# London Terminal Control Area (LTMA)

**NATS**

Future Airspace Strategy (FASI)  
Stage 3 Early Engagement: Position Report  
Collate and Review Responses  
ACP-2020-043 / -044 / -045

Figure 1 Biggin Hill: stakeholder feedback on proposed design envelope & design options

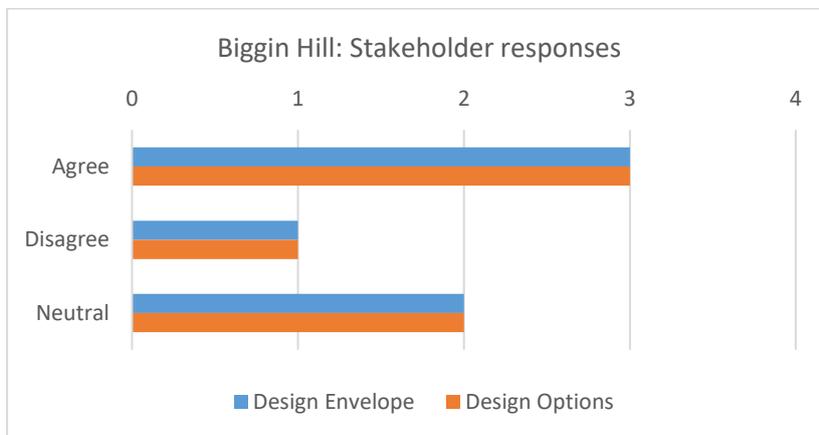
Stakeholder	Feedback	Impact / NERL Response
Biggin Hill	Support proposal – wish to see a westerly arrival option which this supports	No impact on design. NERL will continue to work closely with interdependent ACPs as they develop their designs
Gatwick	Support proposal – takes full view of available airspace	No impact on design
BGA	Disagree - need more information on controlled airspace requirements	No impact on design. CAS requirements will be clarified as the designs progress
Heathrow	Insufficient information at this early stage to determine impact on Heathrow	No impact on design. NERL will continue to work closely with interdependent ACPs as they develop their designs
London City	LCY traffic needs to be accommodated. Hybrid systemisation should accommodate and optimise both systemised and non-systemised routings.	No impact on design. As the airport designs progress, NERL will be keen to explore how flexible the airspace design can be to maximise the hybrid systemisation approach.

Southend	Support proposal – impacts to Southend should be minimised	No impact on design. NERL will continue to work closely with interdependent ACPs as they develop their designs

Figure 2 Bournemouth: stakeholder feedback on proposed design envelope & design options

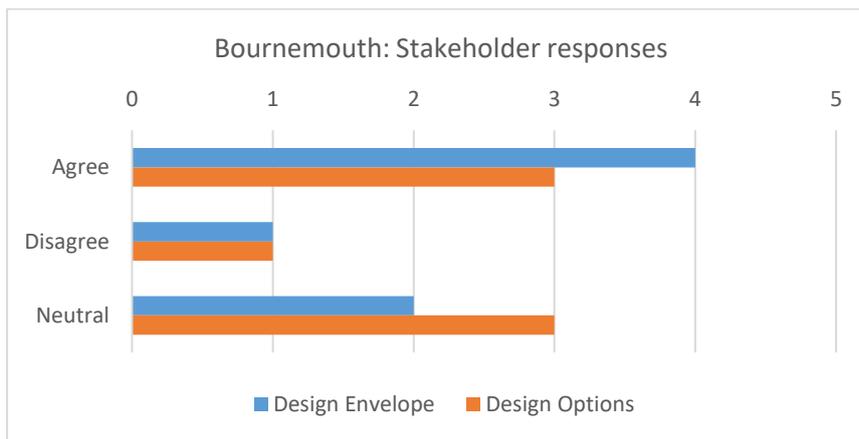
Stakeholder	Feedback	Impact / NERL Response
Bournemouth	Increased airspace and FUA would be of great benefit to BOH.	No impact on design. This support for the network design is captured in the network feedback.
Gatwick	Agree with approach but unclear on why inner hold options to the west of EGHH were discontinued.	No impact on design. Inner holds to the west were discontinued at Stage 2, and the rationale is provided within the Bournemouth Stage 2 documents (Ref 1).
BGA	Disagree - need more information on controlled airspace requirements	No impact on design. CAS requirements will be clarified as the designs progress
MoD	Likely that additional CAS will impact MoD operations. This can be quantified once further detail is available.	No impact on design. NERL will continue to work closely with the MoD to determine operational airspace requirements in line with DP5 & DP7.
Jersey ATC	No impact to Jersey at this stage.	No impact to design.

Figure 3 Farnborough: stakeholder feedback on proposed design envelope & design options

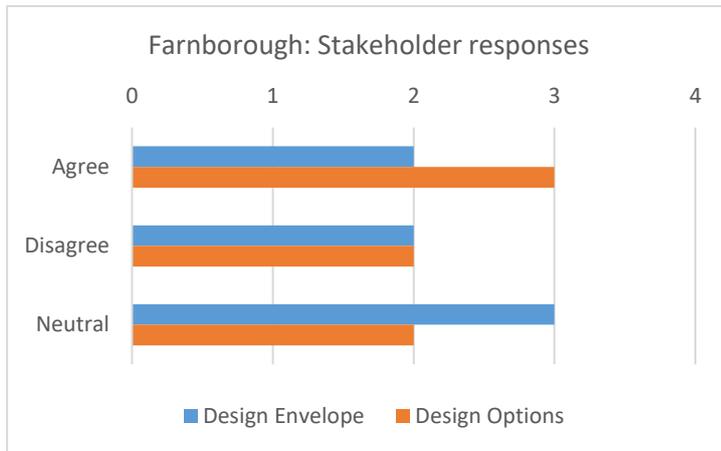
Stakeholder	Feedback	Impact / NERL Response
Biggin Hill	Disagree – appears to reduce option for westerly low-level transit route to/from Biggin Hill, which would benefit frequent re-positioning flights.	No impact on design. This engagement is focused on arrival structures above 7,000ft. The feasibility of a low-level transit route between airports would need to be determined during collaborative work by relevant airports.
Bournemouth	Require engagement with EGLF to ensure a cohesive plan moving forward.	No impact on design. NERL would support and encourage collaborative design between the FASI airports..
BGA	Disagree - need more information on controlled airspace requirements.	No impact on design. CAS requirements will be clarified as the designs progress.
Farnborough	Agree with approach and understand design envelope could be revised as their Stage 2 designs develop.	No impact on design. The constraints and design elements do not prevent NERL from adapting or amending the refined Design Envelope or proposed options if required, as a result of further development or stakeholder feedback.

Gatwick	Agree with approach but unclear on why the airspace to the north and east of EGLF were discontinued.	No impact on design. Inner holds to the north and east were discontinued at Stage 2, and the rationale is provided within the Farnborough Stage 2 documents (Ref 1).
Heathrow	Insufficient information at this early stage to determine impact on Heathrow departures.	No impact on design. NERL will continue to work closely with interdependent ACPs as they develop their designs
MoD	Likely that additional CAS will impact MoD operations. This can be quantified once further detail is available.	No impact on design. NERL will continue to work closely with the MoD to determine operational airspace requirements in line with DP5 & DP7.

Figure 4 Gatwick: stakeholder feedback on proposed design envelope & design options

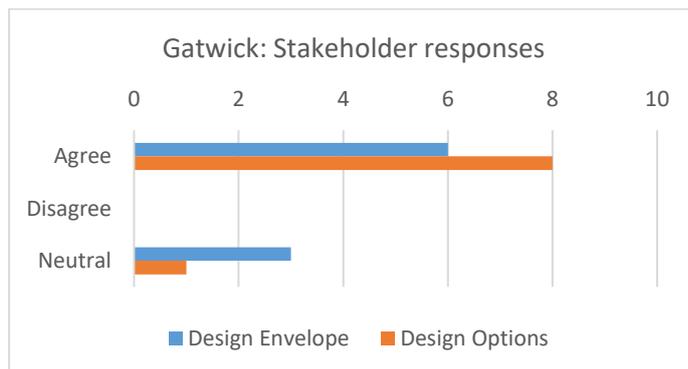
Stakeholder	Feedback	Impact / NERL Response
British Airways (Gatwick)	Support proposals	No impact on design.
British Airways	Support proposals – support point merge removal.	No impact on design.
Delta Airlines	Support design options – arrivals over LHR could be accomplished. Vertical separation would allow NW or SW sector to be included.	No impact on design. Regardless of arrival direction, the location of a holding facility in the NW or SW sectors would not be viable, due to the constraints described within engagement.
Emirates Airline	Support proposals	No impact on design.
Gatwick Airport	Agree with approach but unclear on why the airspace to the north, northeast and northwest of the airfield were already discontinued.	No impact on design. Design options to the north, northeast and northwest of the airfield were discontinued at Stage 2, and the rationale is provided within the Gatwick Stage 2 documents (Ref 1).

London City Airport	LCY traffic needs to be accommodated. Hybrid systemisation should accommodate and optimise both systemised and non-systemised routings.	No impact on design. As the airport designs progress, NERL will be keen to explore how flexible the airspace design can be to maximise the hybrid systemisation approach.
Southend Airport	Support proposal – impacts to Southend should be minimised.	No impact on design. NERL will continue to work closely with interdependent ACPs as they develop their designs.
TUI Airline	Support proposals	No impact on design.
Wizzair	Support proposals. Query how flight planning will be impacted, and how plannable holds will be.	No impact on design. It is not within scope to revise flight planning arrangements. The RAD will continue to provide the appropriate routings for flight planning. Arrival structures will be part of the STAR as per today.

Figure 5 Heathrow: stakeholder feedback on proposed design envelope & design options

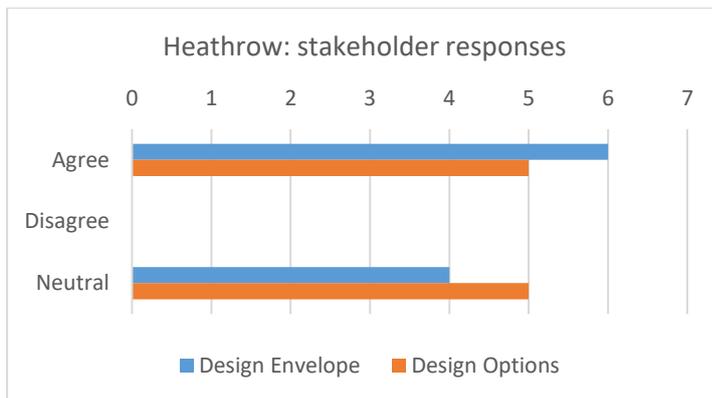
Stakeholder	Feedback	Impact / NERL Response
British Airways	Support proposals – support point merge removal.	No impact on design.
MoD (RAF Northolt)	Northolt need to understand possible options for independent holds. This early design does not provide sufficient detail for this.	No impact on design. NERL will continue to work closely with RAF Northolt to provide sufficient detail on potential independent hold.
Delta Airlines	Support proposals – Heathrow traffic should be prioritized to benefit the entire LTMA.	No impact to design. NERL are seeking to apply our design principles across the entire LTMA and all sponsor airports.
Gatwick Airport	Heathrow design envelope explains refinement fully, including interface with proposed network structures. The assessment for 4 holds is not fully justified.	No impact on design. The design was progressed from Stage 2, and the rationale for 4 holds is provided within the Heathrow Stage 2 document.

Heathrow	This engagement needs to clearly describe it is for arrival structures only above 7,000ft and does not include departure / transition factors. Continued collaborative engagement from NERL with Heathrow through Stage 3 will assist.	No impact on design. The engagement material states the design envelope is for potential arrival structures above 7,000ft only. NERL will continue to work closely with interdependent ACPs as they develop their designs.
London City Airport	LCY traffic needs to be accommodated. Hybrid systemisation should accommodate and optimise both systemised and non-systemised routings.	No impact on design. As the airport designs progress, NERL will be keen to explore how flexible the airspace design can be to maximise the hybrid systemisation approach.
Luton Airport	The design envelope could be seen to indicate no routes at all within the excluded area to the west.	No impact on design. The engagement material states the design envelope is for potential arrival structures only.

Southend Airport	Support proposal – impacts to Southend should be minimised.	No impact on design. NERL will continue to work closely with interdependent ACPs as they develop their designs.
Stansted	Support proposals – support point merge removal.	No impact on design.

Figure 6 London City: stakeholder feedback on proposed design envelope & design options

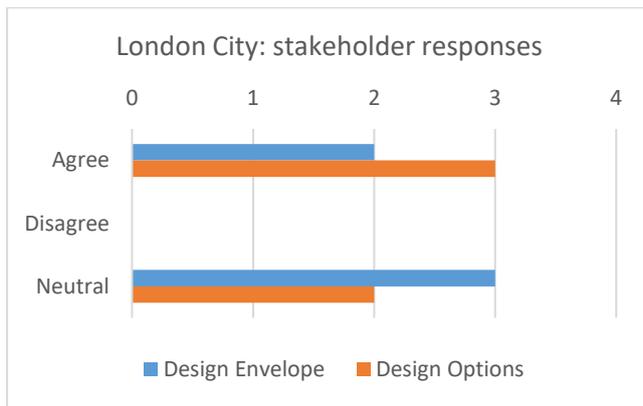
Stakeholder	Feedback	Impact / NERL Response
Biggin Hill	Support proposal – supports EGKB and EGLC having independent arrival structures.	No impact on design. NERL will continue to explore the feasibility of independent arrival structures where possible.
Gatwick	Agree with approach but unclear on why the airspace to the west, southwest and north of the airfield were already discontinued.	No impact on design. Design options to the west, southwest and north of the airfield were discontinued at Stage 2, and the rationale is provided within the London City Stage 2 documents (Ref 1).
Heathrow	Insufficient information at this early stage to determine impact on Heathrow	No impact on design. NERL will continue to work closely with interdependent ACPs as they develop their designs
London City	Design is similar to today and may be limiting the potential benefits and opportunity for new routes for LCY. The hybrid systemisation model needs to fully explore the potential benefits of tactical shortcuts – including demand and predictability to ensure flight planning gains. This appears to be ‘do minimum’ for LCY.	No impact on design. The refined design envelope provides the capability for either a point merge or inner holds. As the airport designs progress, NERL will be keen to explore how flexible the airspace design can be to maximise the hybrid systemisation approach, working with LCY to consider the potential impact of changing traffic flows

Southend	Support proposal – impacts to Southend should be minimised	No impact on design. NERL will continue to work closely with interdependent ACPs as they develop their designs

Figure 7 Luton: stakeholder feedback on proposed design envelope & design options

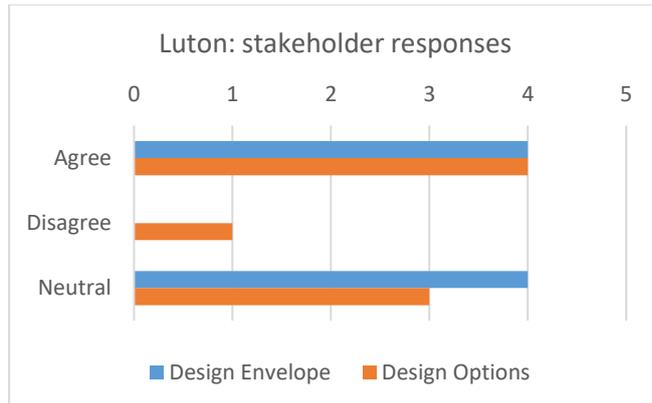
Stakeholder	Feedback	Impact / NERL Response
London City	LCY traffic needs to be accommodated. Hybrid systemisation should accommodate and optimise both systemised and non-systemised routings.	No impact on design. As the airport designs progress, NERL will be keen to explore how flexible the airspace design can be to maximise the hybrid systemisation approach.
Luton	Concerns on viability of point merge, given the airspace required combined with fuel inefficiency.	<b>May impact on design.</b> The point merge concept has been retained at this stage but your feedback will be considered as the design options are further developed.
MoD	Support excluding any additional CAS from the design envelope.	No impact on design.
Ryanair	Agree with approach. Point merge works well in Dublin.	No impact on design.
Stansted	Disagree with design options; specifically, a point merge may create limitations for both EGSS & EGGW and does not appear to align with DP8 or DP10.	<b>May impact on design.</b> The point merge concept has been retained at this stage but your feedback will be considered as the design options are further developed.

Wizzair	Would like more detail on the environmental benefit of NAVPI change proposed	No impact on design. This is part of a separate ACP which is currently in development. Please see the CAA portal page for ACP-2021-061 for further details.

Figure 8 RAF Northolt: stakeholder feedback on proposed design envelope & design options

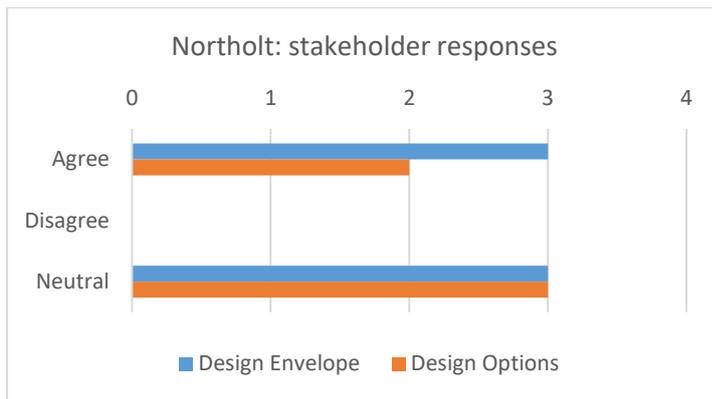
Stakeholder	Feedback	Impact / NERL Response
Delta Airlines	Heathrow traffic should be prioritized to benefit the entire LTMA. Sharing holds may provide a disbenefit for Heathrow.	No impact to design. NERL are seeking to apply our design principles across the entire LTMA and all sponsor airports. Design options are currently considering both shared and independent holds.
Gatwick Airport	Same as EGLL. Heathrow design envelope explains refinement fully, including interface with proposed network structures. The assessment for 4 holds is not fully justified.	No impact on design. The design was progressed from Stage 2, and the rationale for 4 holds is provided within Stage 2 documents.
Heathrow	Insufficient information at this early stage to determine impact on Heathrow	No impact on design. NERL will continue to work closely with interdependent ACPs as they develop their designs
MoD	Northolt need to understand possible options for independent holds vs interdependent holds. This early design does not provide sufficient detail for this.	No impact on design. NERL will continue to work closely with MoD (RAF Northolt) to provide sufficient detail on potential independent hold.

RAF Northolt	RAF Northolt requests design options for an independent RAF Northolt hold.	No impact on design. Design options are currently considering both shared and independent holds. NERL will continue to work closely with MoD (RAF Northolt) to provide sufficient detail on potential independent hold.
Southend	Support proposal – impacts to Southend should be minimised	No impact on design. NERL will continue to work closely with interdependent ACPs as they develop their designs

Figure 9 Southampton: stakeholder feedback on proposed design envelope & design options

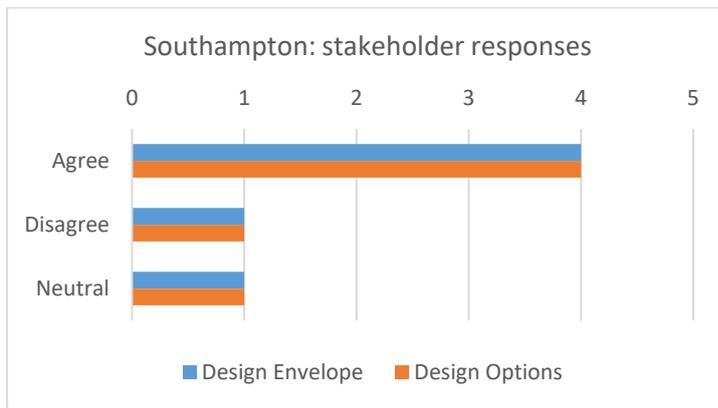
Stakeholder	Feedback	Impact / NERL Response
Bournemouth	BOH require engagement with SOU to ensure a cohesive plan moving forward.	No impact on design. NERL would support and encourage collaborative design between the Solent airports.
BGA	Disagree - need more information on controlled airspace requirements.	No impact on design. CAS requirements will be clarified as the designs progress
Gatwick	Same approach as EGLL - a fair assessment.	No impact on design.
Jersey ATC	No impact to Jersey at this stage.	No impact to design.
Loganair	Controlled airspace at EGHI should be amended so that aircraft from the north can remain in CAS without manoeuvres such as the "Winchester Loop"	NERL will continue to develop the network design above 7,000ft in line with DP5.
MoD	Likely that additional CAS will impact MoD operations. This can be quantified once further detail is available.	No impact on design - NERL will continue to work closely with the MoD to determine operational airspace requirements in line with DP5 & DP7.

Figure 10 Southend: stakeholder feedback on proposed design envelope & design options

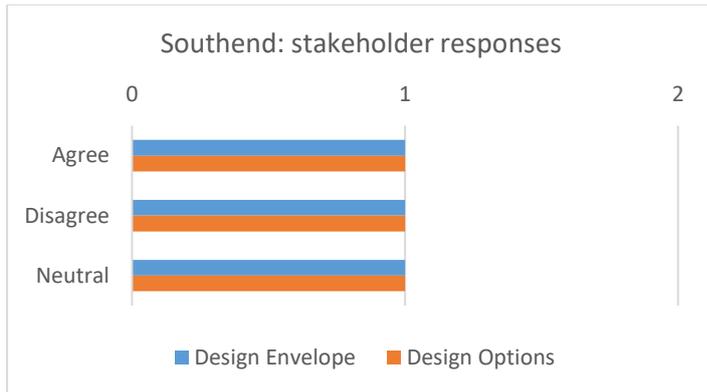
Stakeholder	Feedback	Impact / NERL Response
BGA	Disagree - need more information on controlled airspace requirements.	No impact on design. CAS requirements will be clarified as the designs progress
London City	LCY traffic needs to be accommodated. Hybrid systemisation should accommodate and optimise both systemised and non-systemised routings.	No impact on design. As the airport designs progress, NERL will be keen to explore how flexible the airspace design can be to maximise the hybrid systemisation approach.
Southend	Agree with proposal to do nothing or collaborate with EGKB/EGLC to design suitable structures. Southend priority is network connectivity for departures so need any arrival structure to support this. A structure may impact CAS requirements.	No impact on design. NERL recognise the aspirations of Southend. NERL will continue to work closely with interdependent ACPs as they develop their designs

Figure 11 Stansted: stakeholder feedback on proposed design envelope & design options

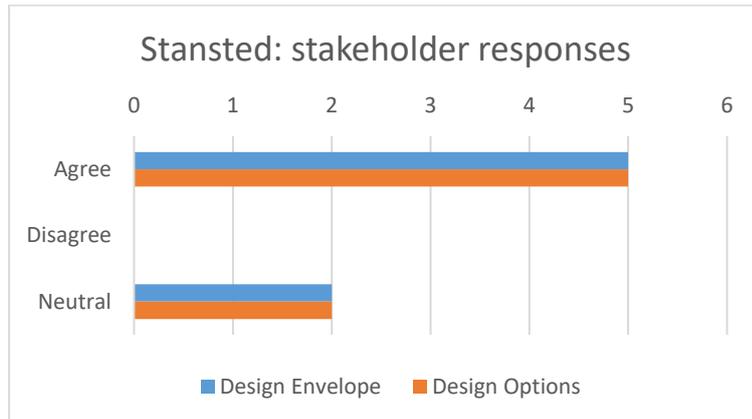
Stakeholder	Feedback	Impact / NERL Response
Delta Airlines	Connectivity with neighbouring airspace should be considered to maximise CO <sub>2</sub> benefit, due to close proximity to TMA border	No impact on design. NERL are seeking to apply our design principles across the entire LTMA and all sponsor airports.
London City	LCY traffic needs to be accommodated. Hybrid systemisation should accommodate and optimise both systemised and non-systemised routings.	No impact on design. As the airport designs progress, NERL will be keen to explore how flexible the airspace design can be to maximise the hybrid systemisation approach.
Luton Airport	Stansted and Luton envelopes overlap. Do not support any increased dependency between the 2 arrival flows (having been made independent by AD6).	No impact on design. There is no intention within the design to create an interdependency between EGSS and EGGW. Where design envelopes overlap this will be deconflicted as designs progress.

Ryanair	Support proposal – Insufficient information at this early stage to assess potential benefits.	No impact on design. As the designs progress, further detail will be provided on option impacts.
Southend	Support proposal – impacts to Southend should be minimised	No impact on design - NERL will continue to work closely with interdependent ACPs as they develop their designs
Stansted	Support proposal – agree with discontinuation of point merge. Offer collaborative working with NERL to develop their options progressed from Stage 2.	No impact on design. NERL will continue to work closely with interdependent ACPs as they develop their designs.
